WLTP

Comparison of WLTP unified database distributions and WLTC rev2 distributions

Heinz Steven

08.10.2011

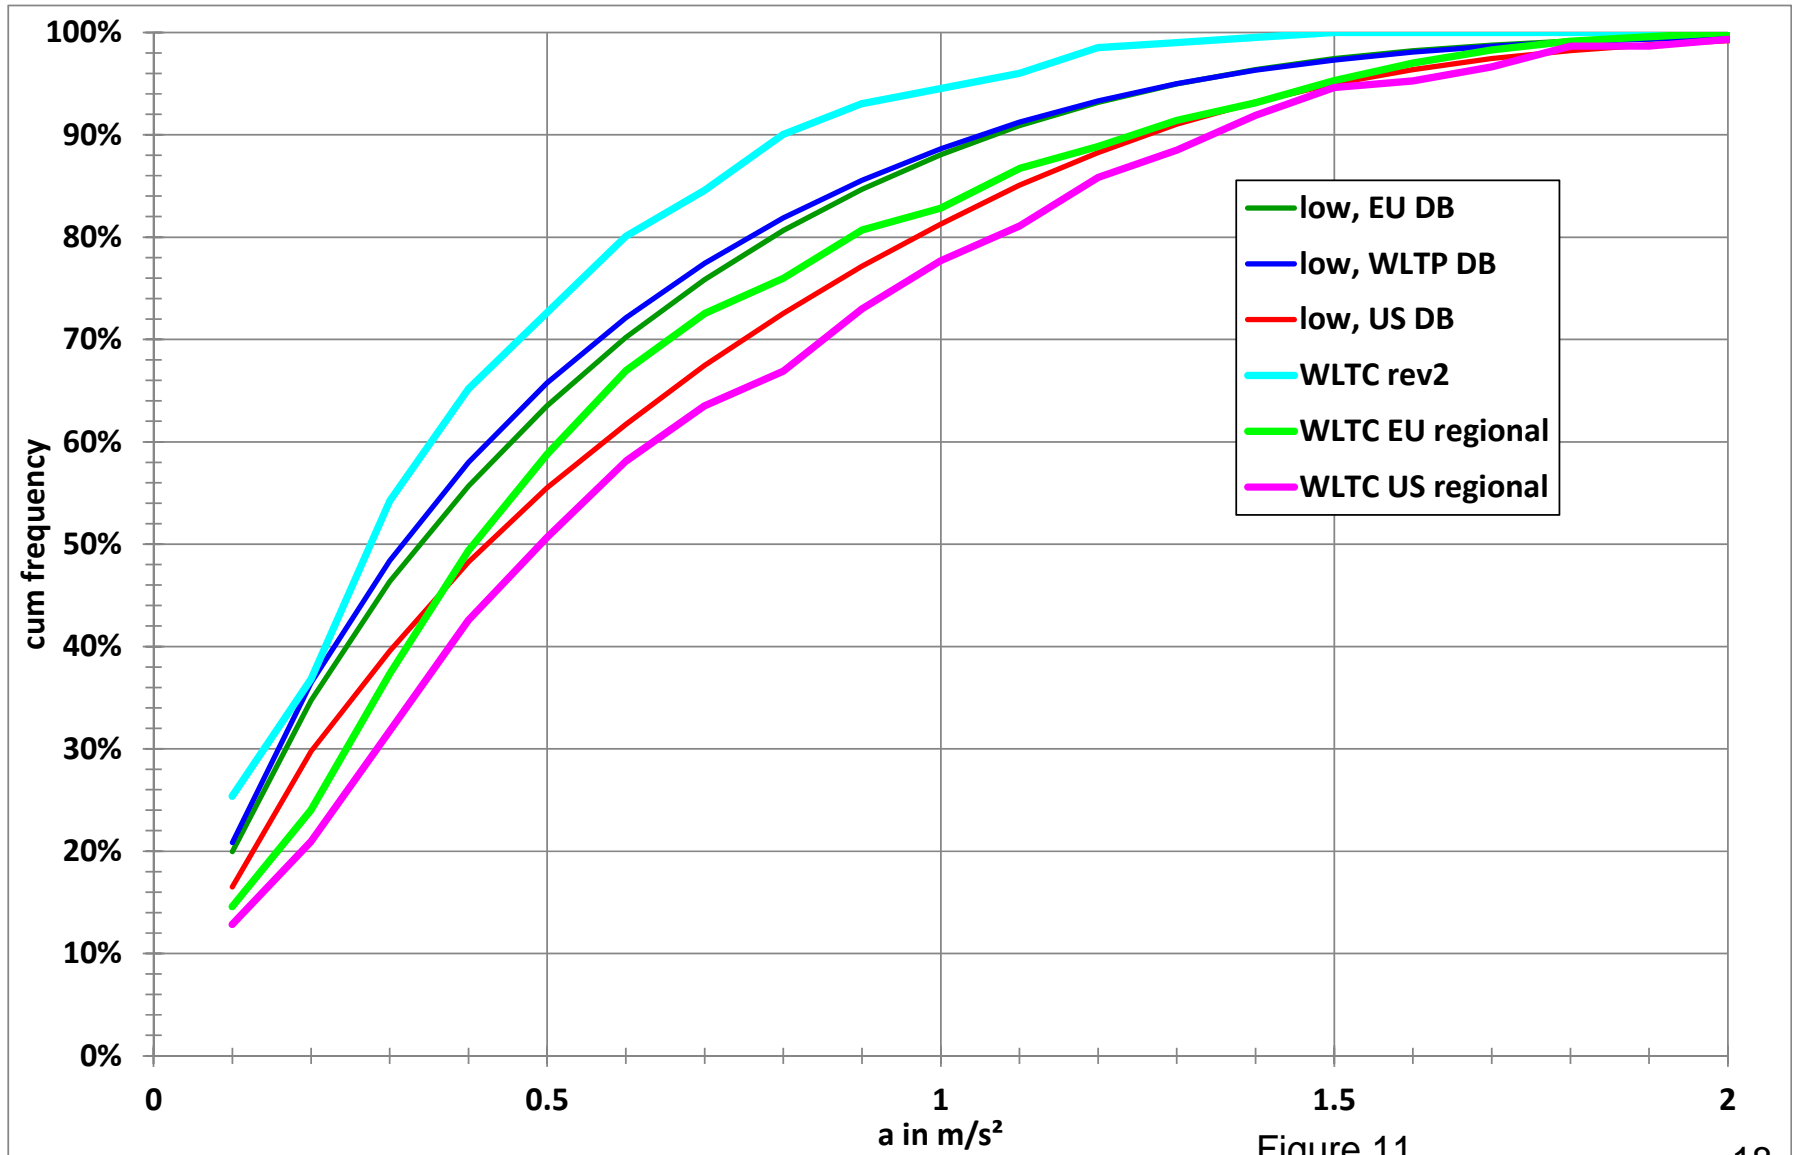
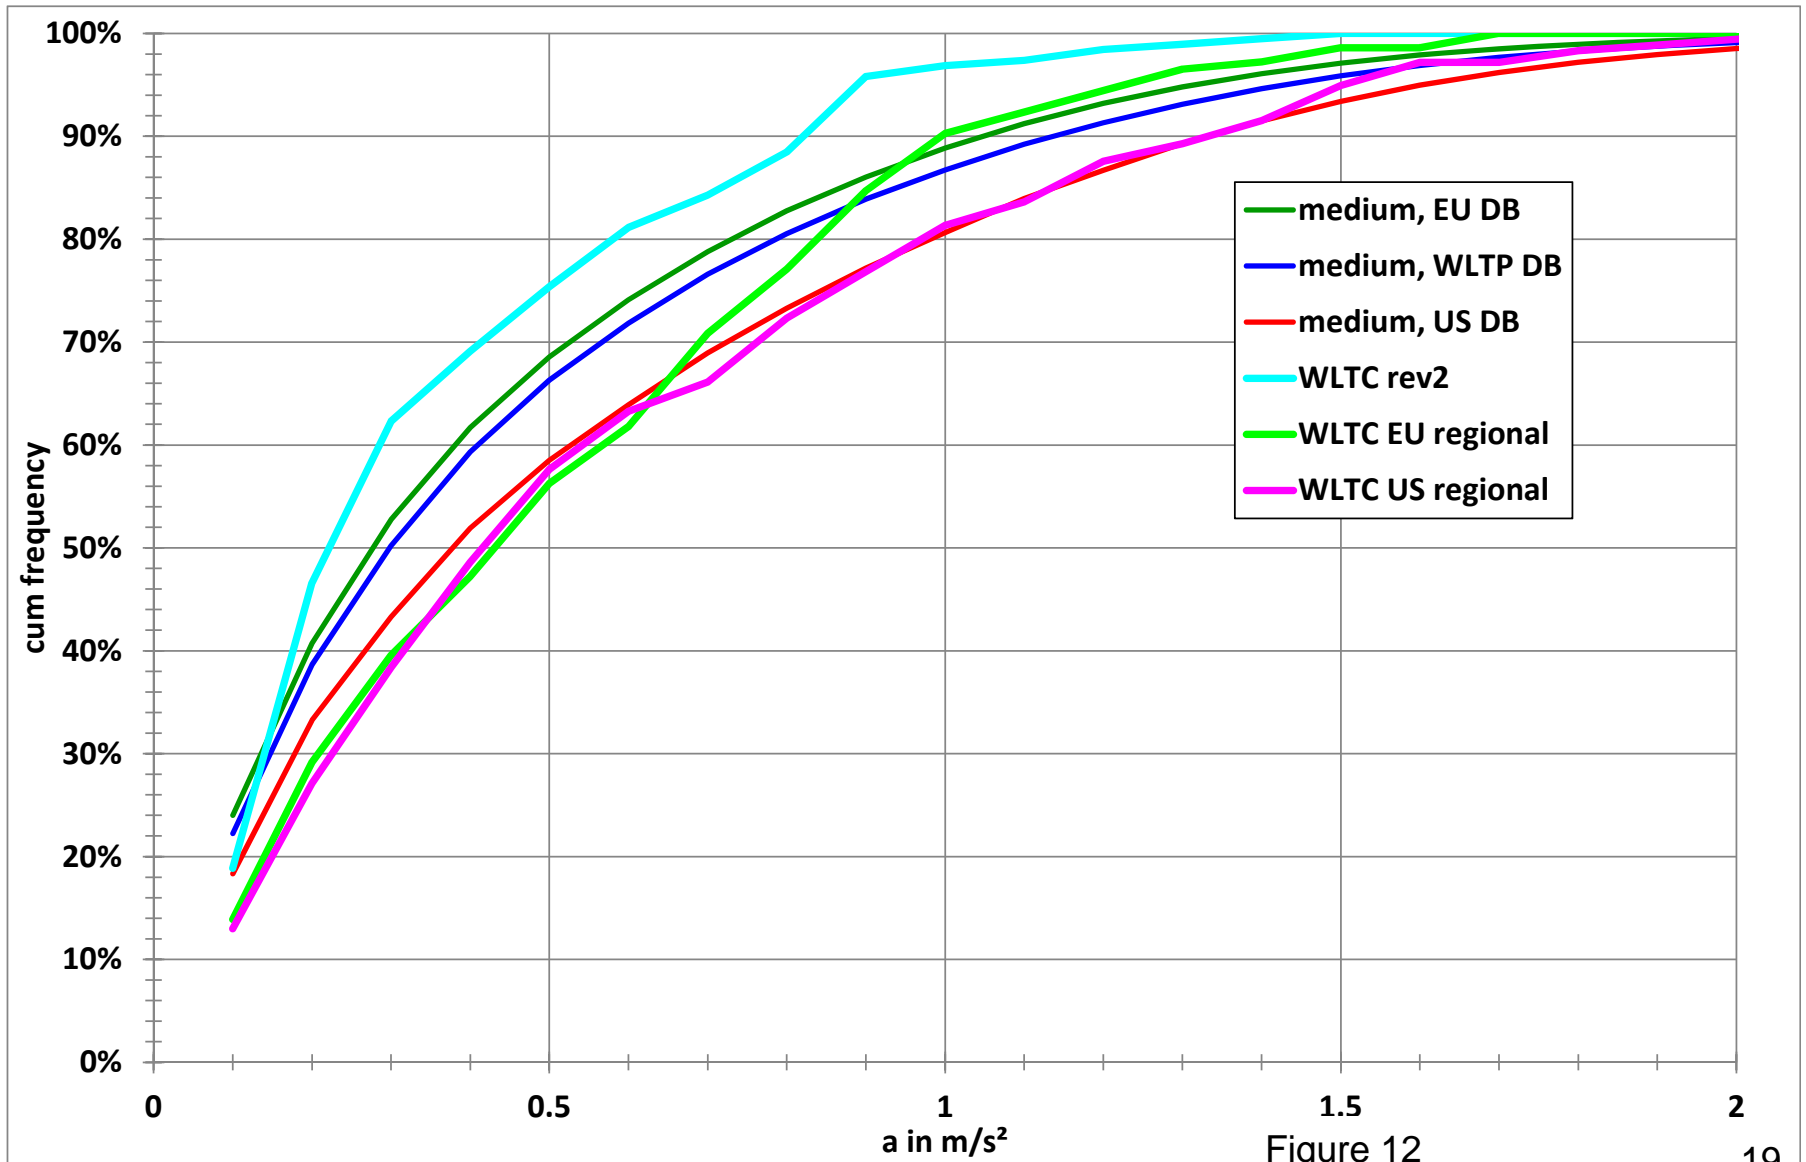
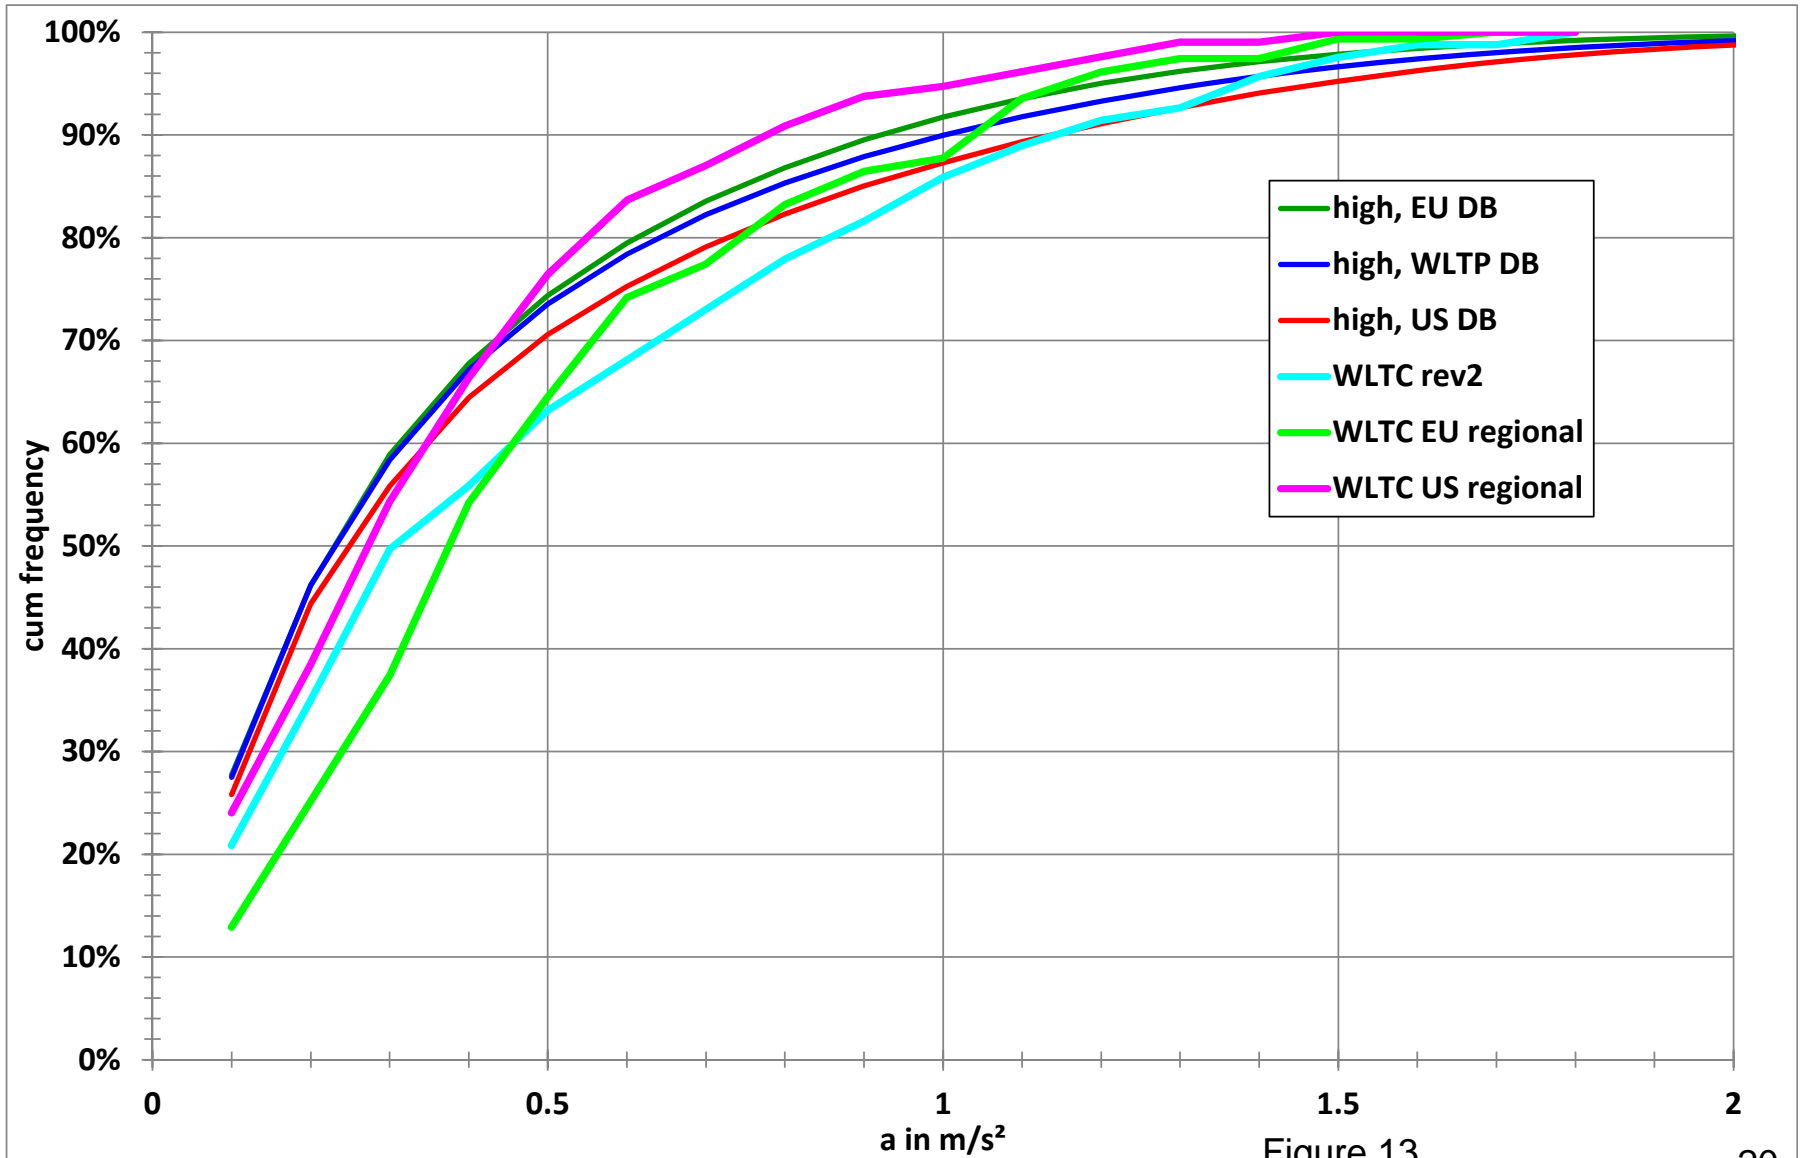
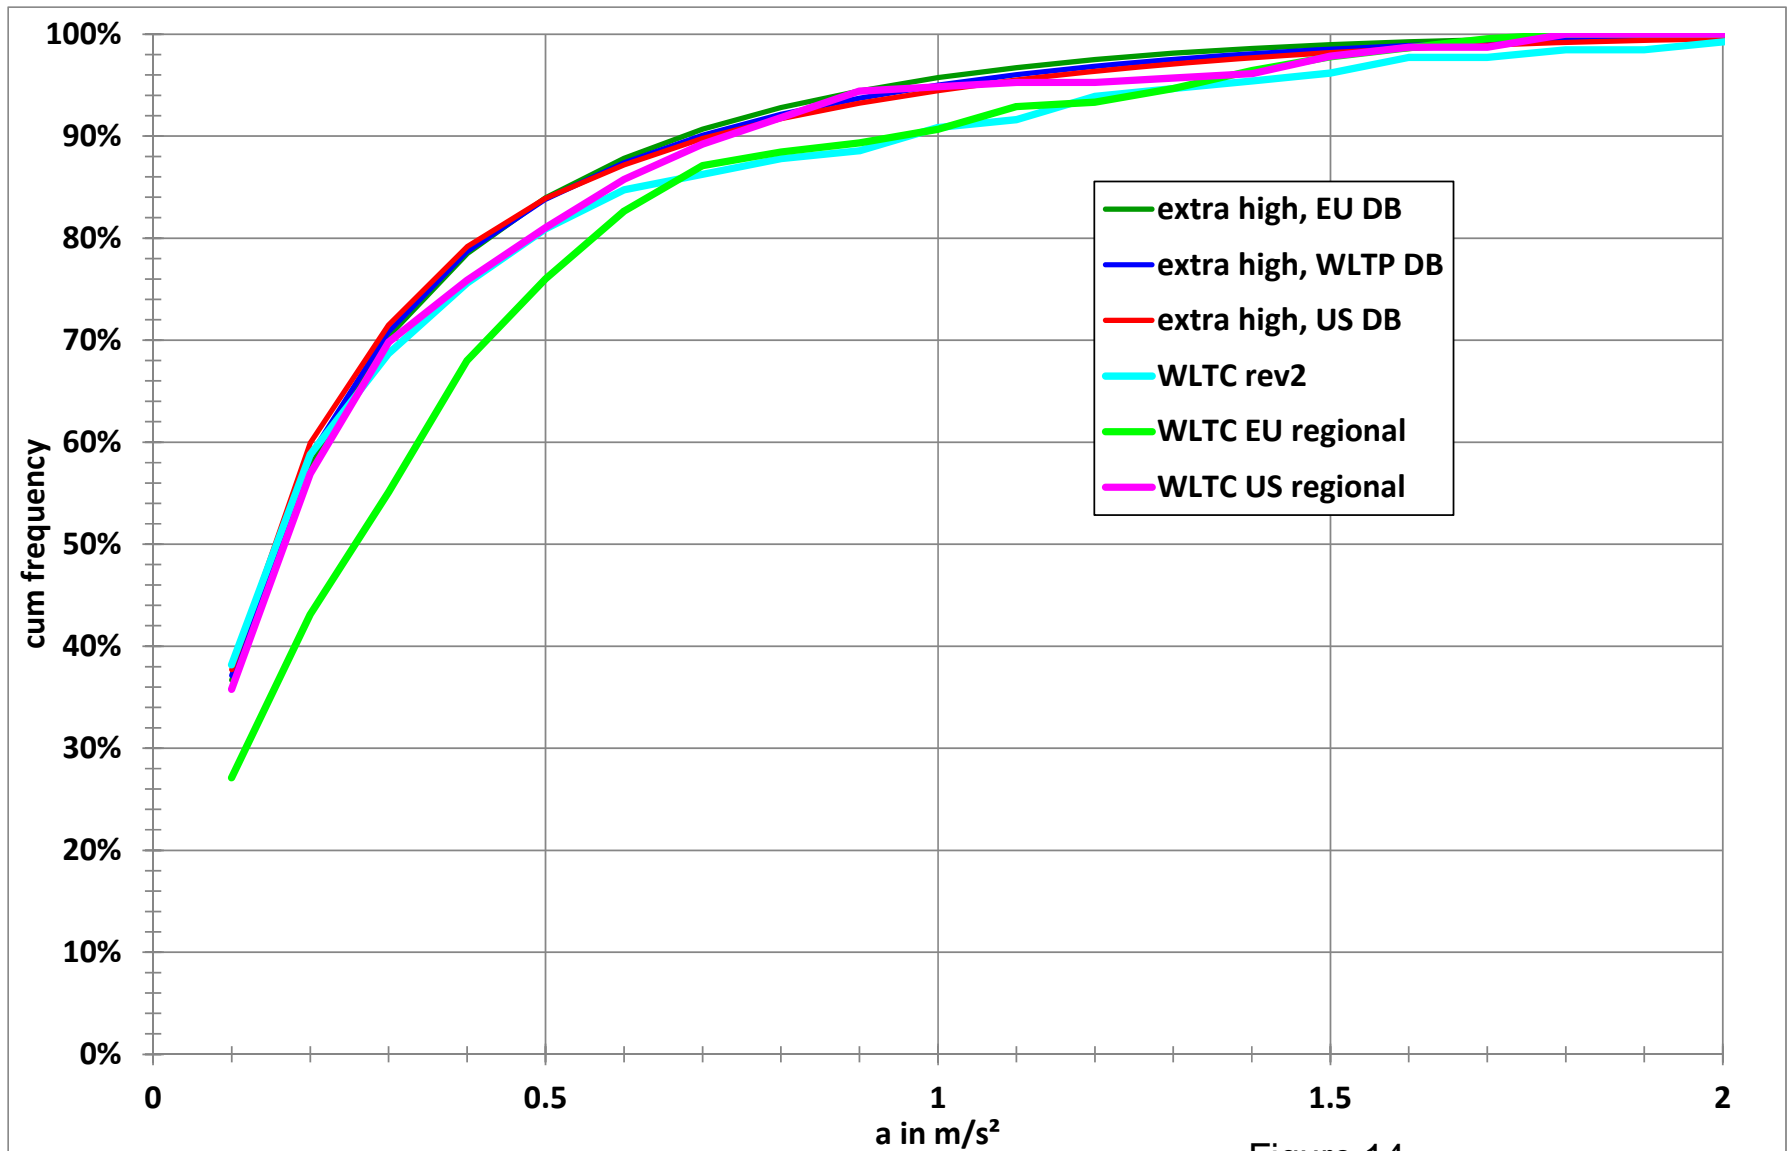
- In order to further check these observations additional analysis work was performed by developing regional cycles for the EU and the US. The key parameters of these cycles are tabled in Annex A.
- Figures 11 to 14 show the results for the positive acceleration sections and the different speed parts.
- First of all it needs to be mentioned that the distributions for the unified WLTP database and the EU regional database are pretty close together, while the distributions of the regional US database show higher dynamics for the low and medium speed parts and less pronounced for the high speed part. The distributions for the extra high speed parts are almost identical.
- The corresponding distributions for the candidate cycles show different trends.

- In case of the low speed part the WLTC rev2 is less dynamic, the regional candidates are more dynamic compared to the database distributions.
- The results for the medium speed part show a different picture: WLTC rev2 once again less dynamic, EU regional in the lower acceleration area more dynamic, in the higher acceleration area good coincidence, US regional with an overall very good fit to the database.
- High speed part: WLTC rev2 and EU regional in the lower acceleration area more dynamic, in the higher acceleration area good coincidence, US regional less dynamic than the database.
- Extra high speed part: WLTC rev2 more dynamic in the middle, EU regional more dynamic and the US regional with a good fit to the corresponding database.
